Re: Mullan Poultry Ltd. P1157-01

I refer to previous Agency correspondence of 6th October last. Please find detailed below the response to the issues raised.

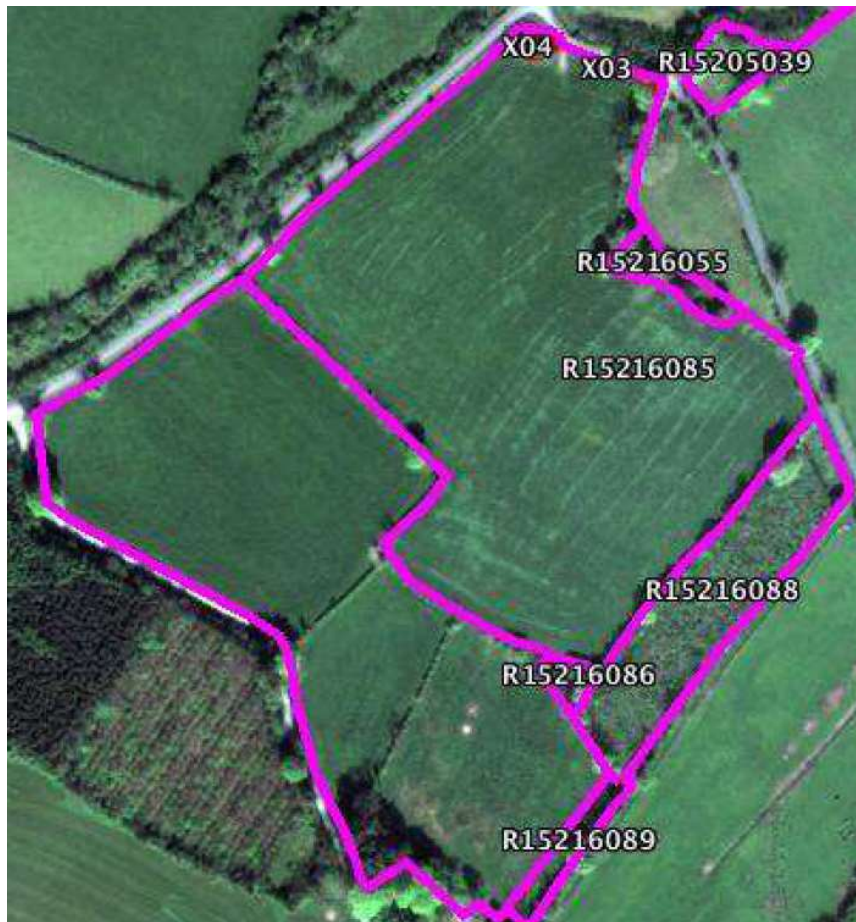
- 2. Update the site plan to include:**
 - a) The stormwater discharge points;**
 - b) Labelling of the poultry houses to differentiate between the two houses; and**
 - c) Removal of the reference to “free range”.**

Please refer to updated Site Plan enclosed.
